**Job Name:** Land East of Lunce's Hill, Haywards Heath, West Sussex  
**Job No:** 332611520  
**Note No:** 001  
**Date:** September 2025  
**Prepared By:** B Haydon  
**Reviewed By:** N Fern  
**Subject:** Transport Addendum Note – in response to West Sussex County Council Highways and West Sussex County Council Waste  
**Planning Reference:** DM/25/0827

## 2. Response to WSCC Highways Comments

## Appendix B – Site Access Junction – Junctions 11 Outputs

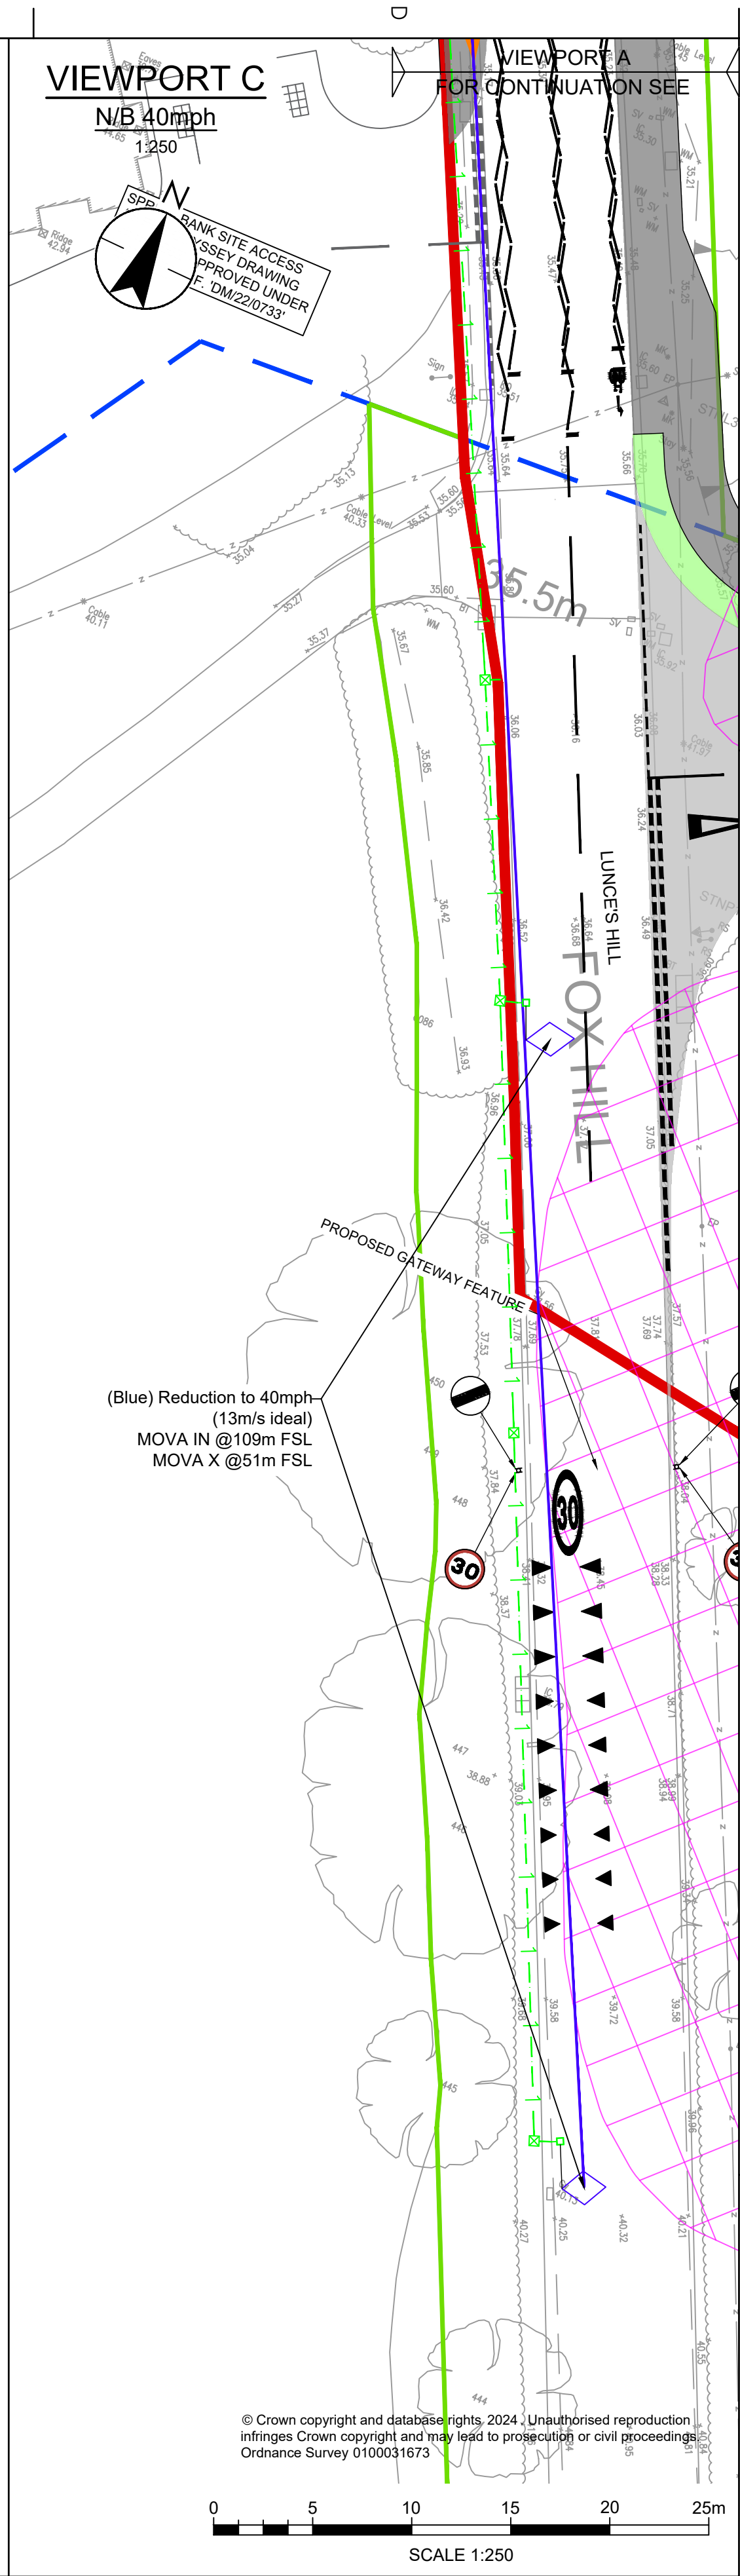
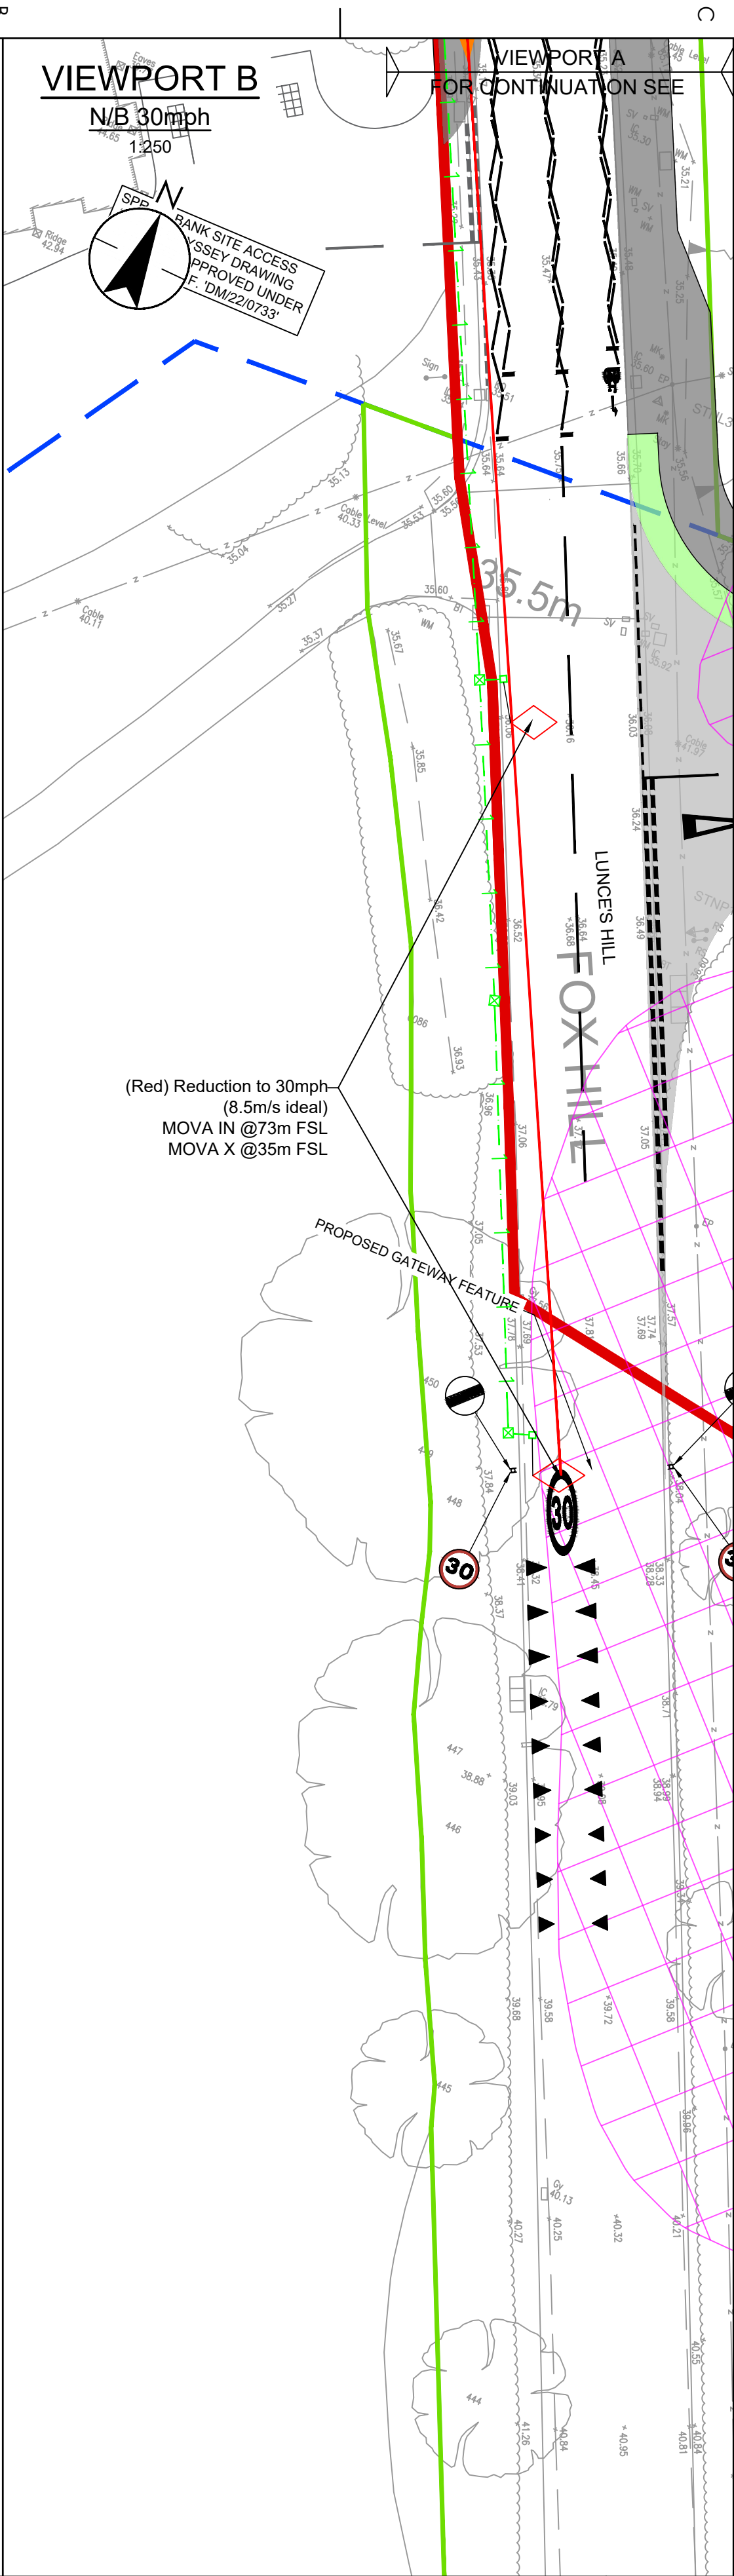
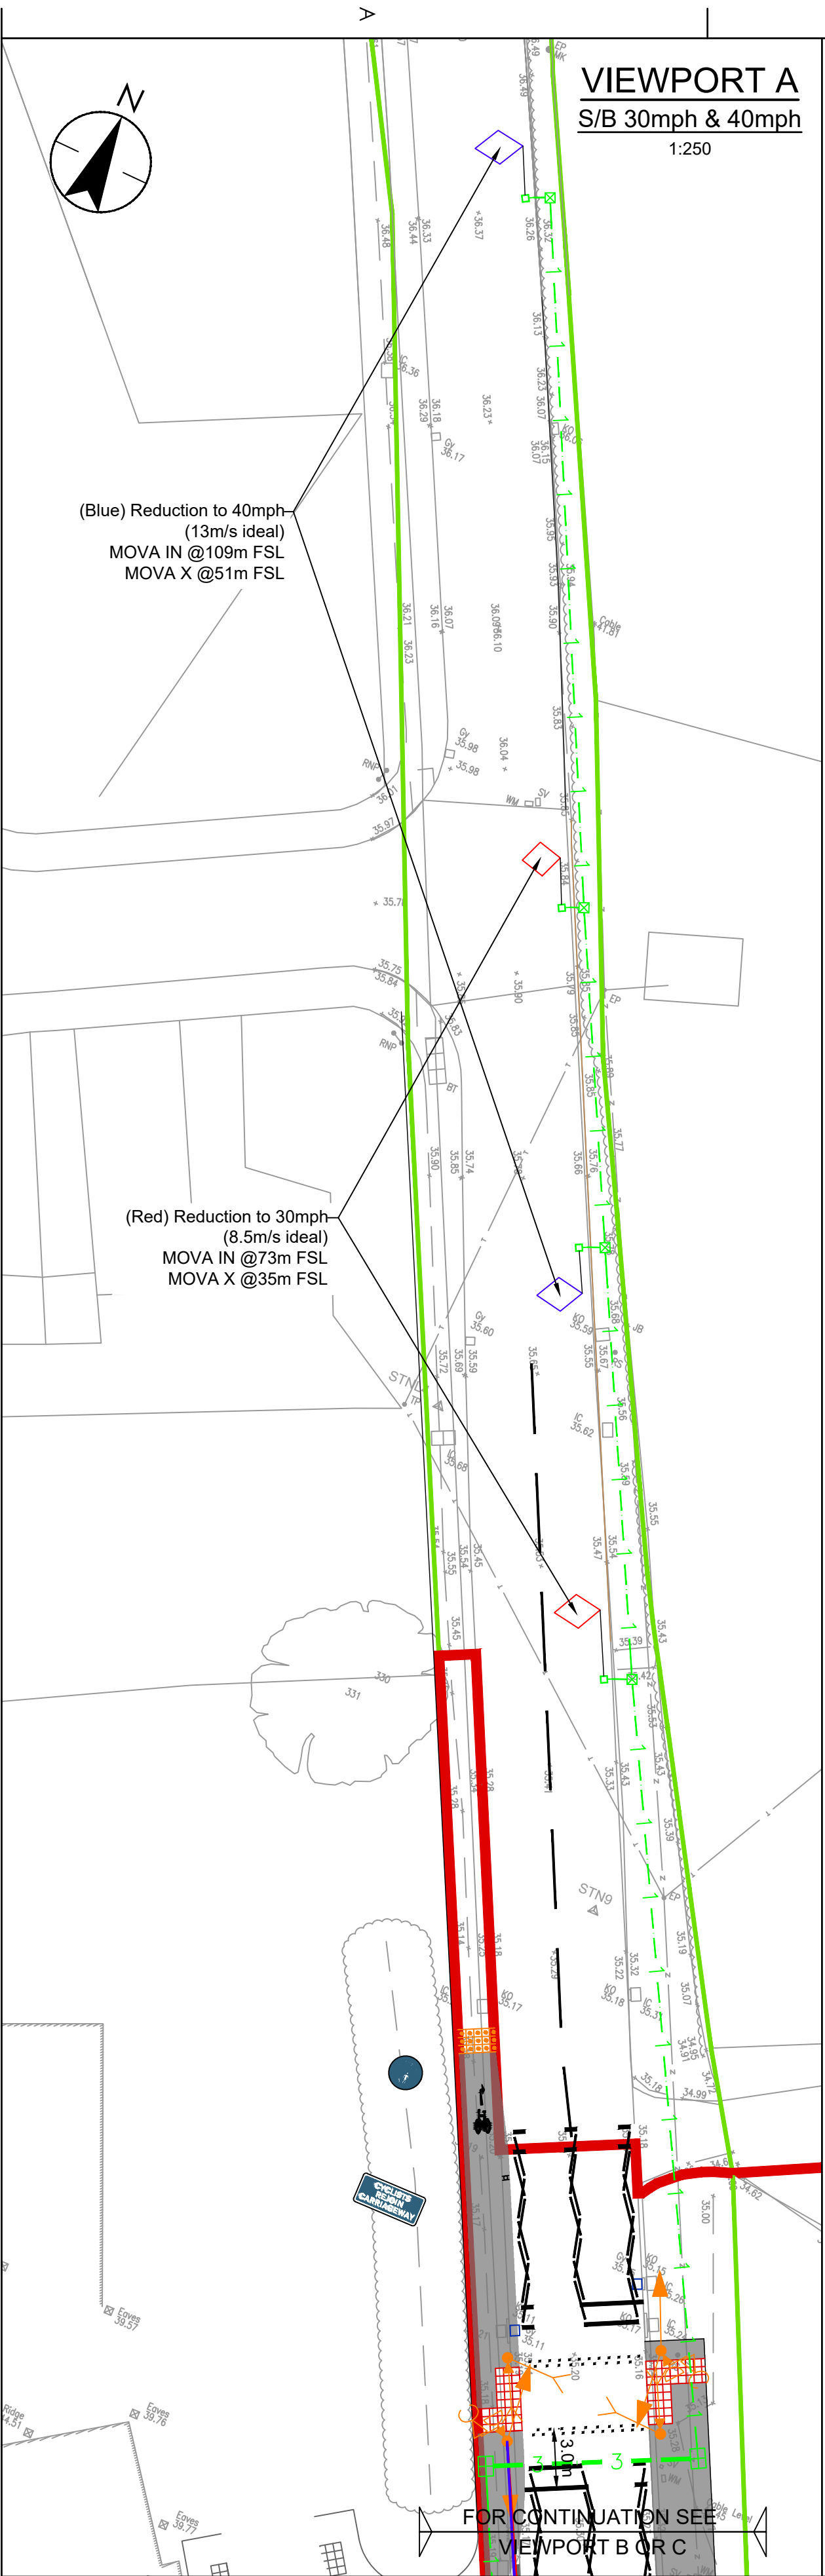
*"With regard to the proposed junction arrangement, the daily traffic flows from the new development might trigger the need to consider further intervention in the design, such as a right-hand turning lane, as informed by DMRB. Applicant to provide junction assessment showing predicted traffic flows through the junction and what consideration, if any, has been given to further intervention."*

- 2.14. The proposed Site access junction has been subject to a junction capacity assessment within TRL's Junctions 11 software (PICADY).
- 2.15. The assessment demonstrated that the junction is forecast to operate well within capacity, with minor levels of queuing and delay – please see screenshot below.

- 2.16. The full Junctions 11 output is provided in **Appendix B**.

## Appendix C – Signal Crossing Detection Options

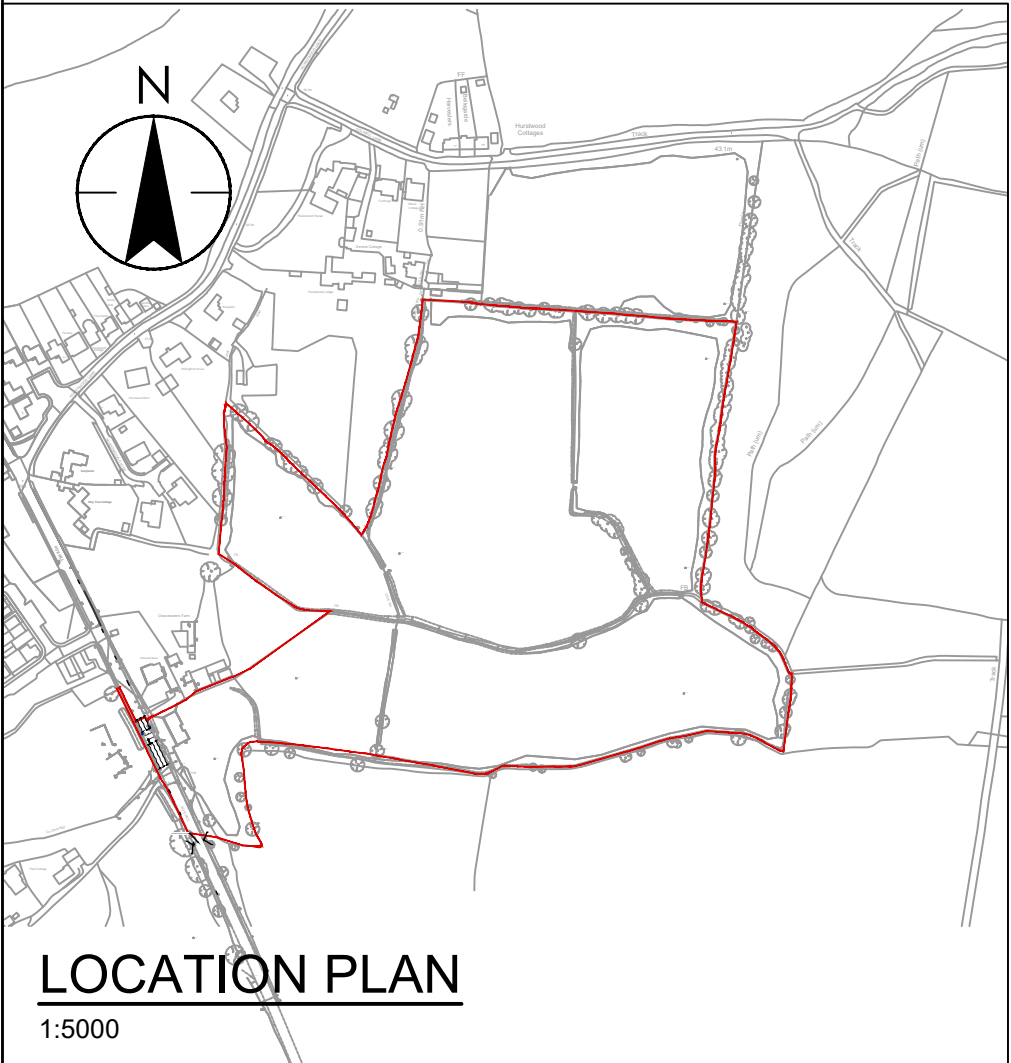
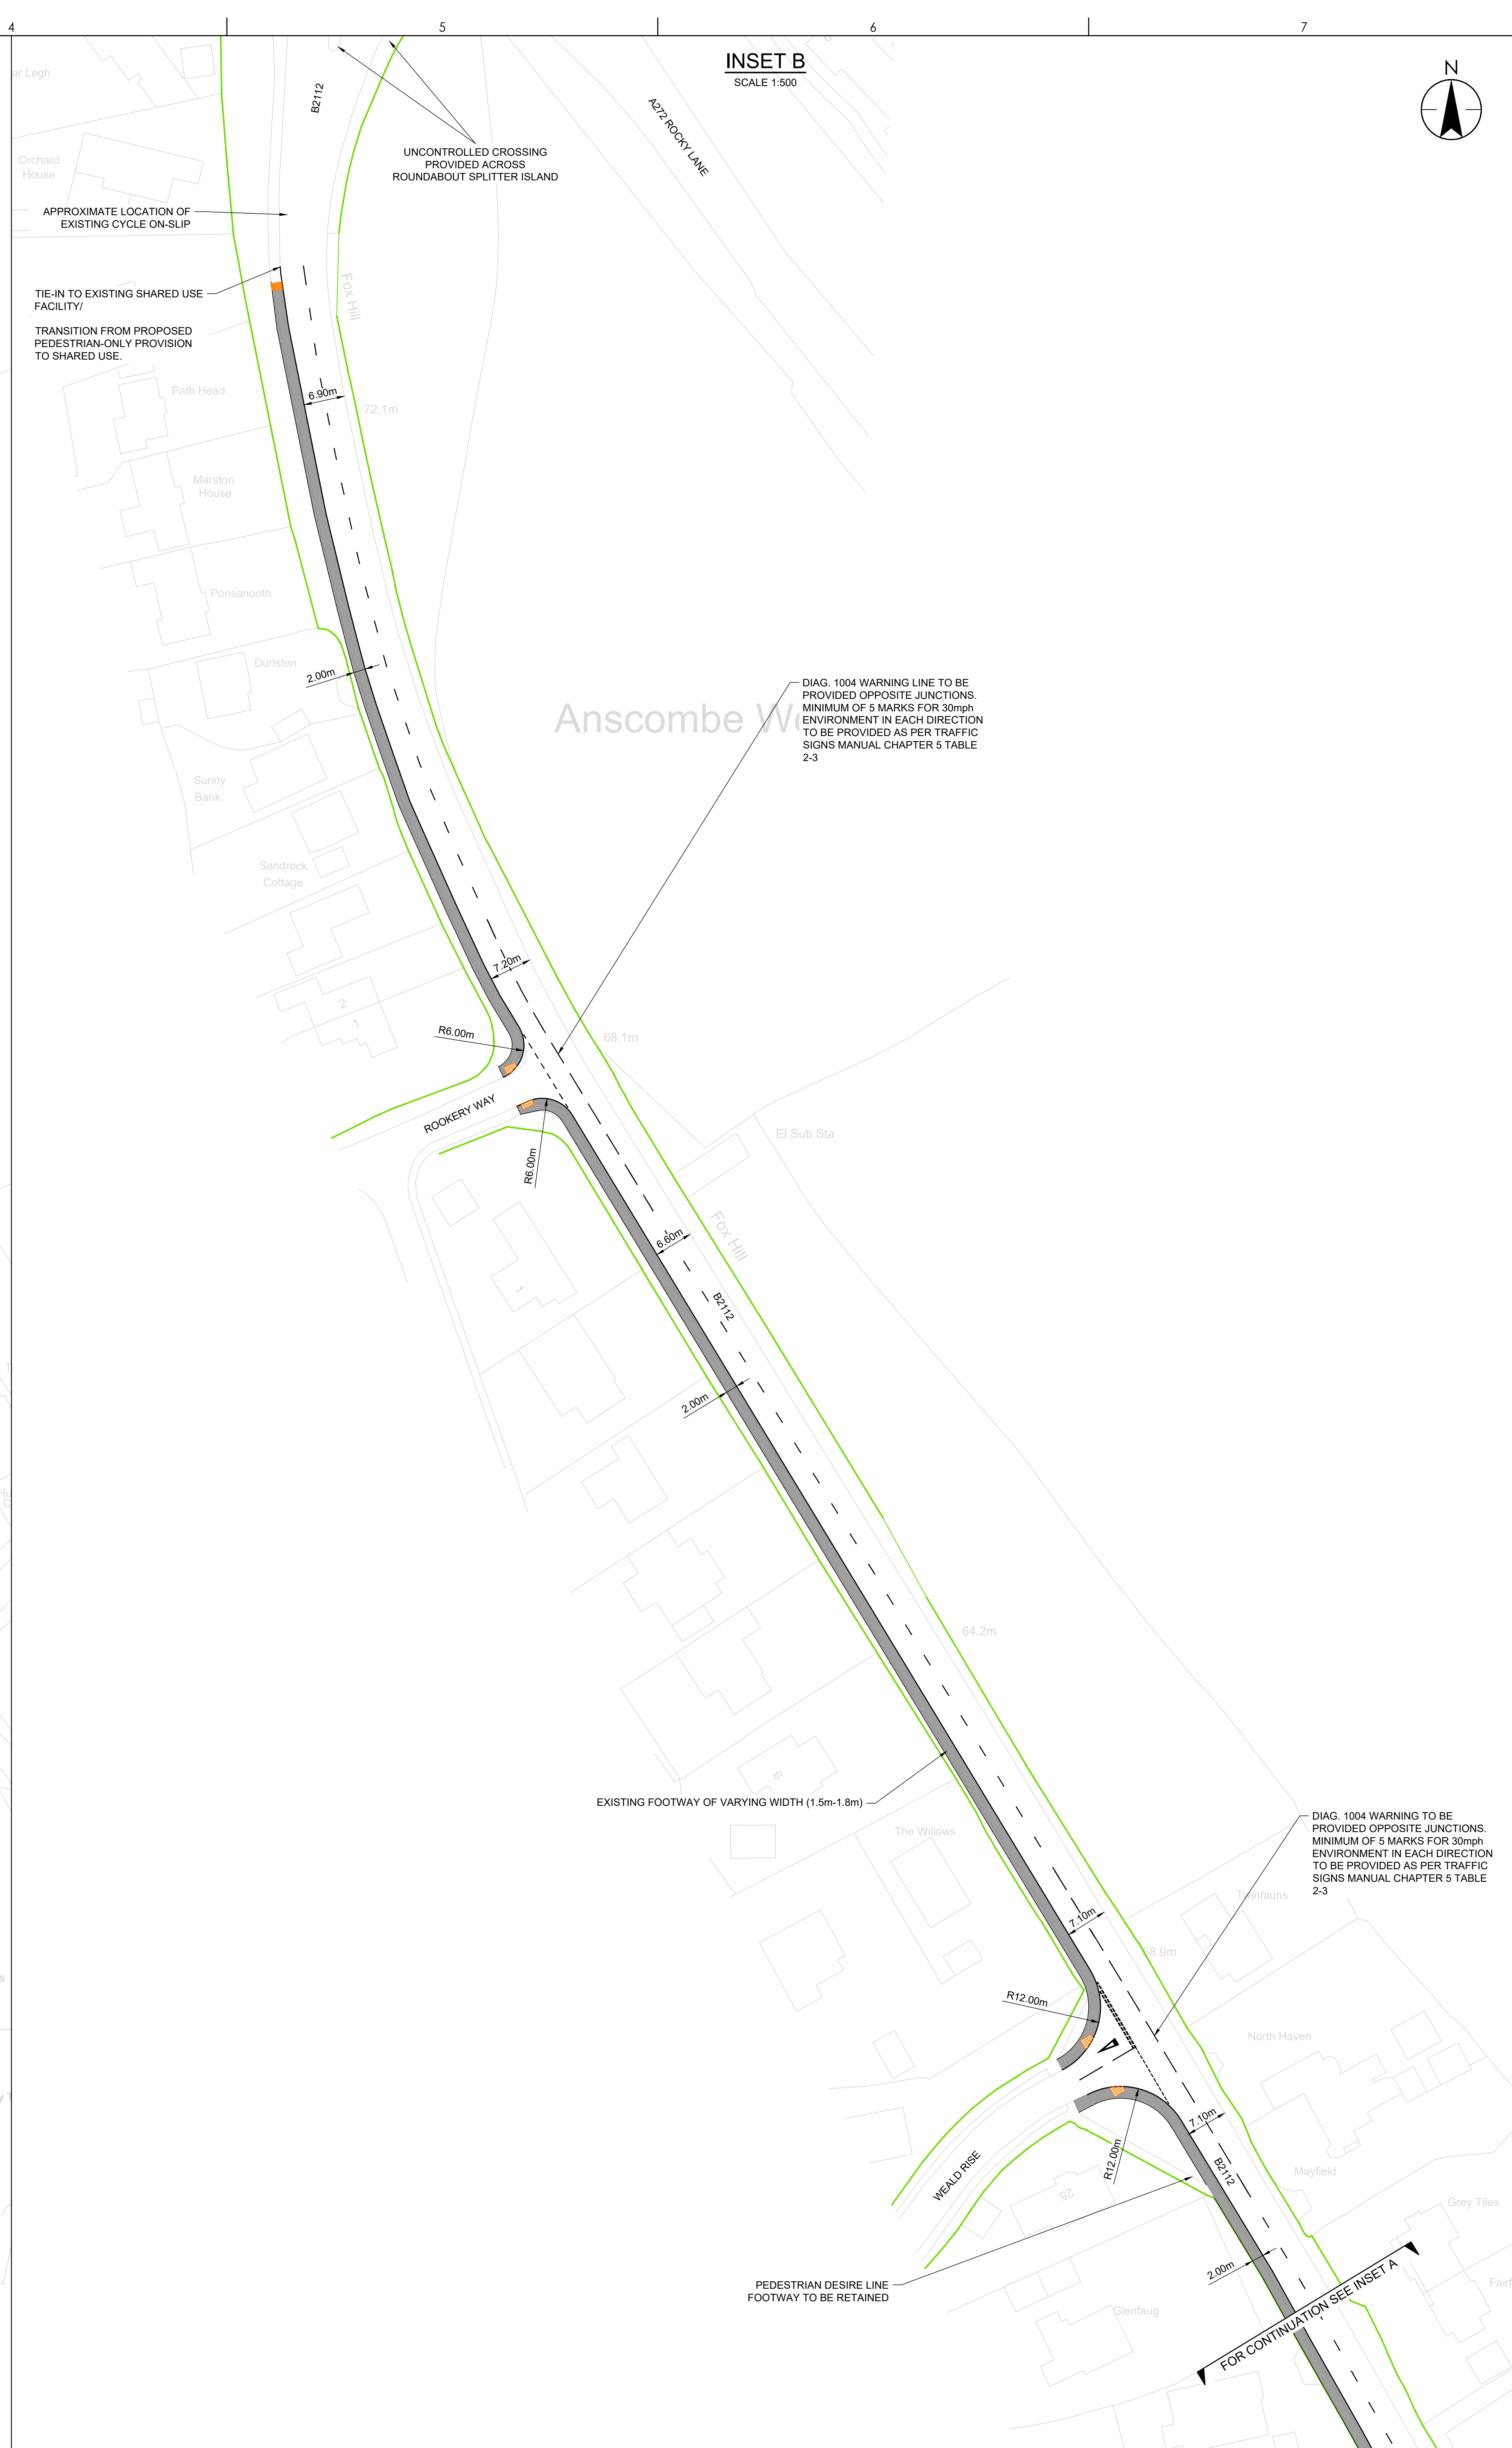
*"The proposed location would necessitate ducting and detection loops being located within East Sussex (above ground vehicle detection wouldn't be an option here due to the vegetation and tree canopy) which could cause some challenges for construction and maintenance. Therefore, it is recommended that the location of the crossing is reviewed with a view to locating it further north (possibly as much as 100m inside the WSCC county border). The foot/cycle way proposed on the eastern side of the road will need to be extended to meet it. The applicant will also need to demonstrate how the location of the crossing fulfils ongoing connectivity for pedestrians with regard to footways and PRow."*

2.19. An initial review into the detection options for the crossing within a 30mph speed limit shows that the ducting and detection loops will extend approximately 60m into ESCC jurisdiction with the crossing remaining in its current proposed location. This review is shown on the crossing detection options drawing provided in **Appendix C**.

2.20. If the above extents are not acceptable to WSCC, and overhead detection is not possible in this location, an alternative option could be to consider a Tiger crossing in this location which would be within the proposed extended 30mph speed limit, and which would not require detection loops. This would be subject to further discussions with WSCC.
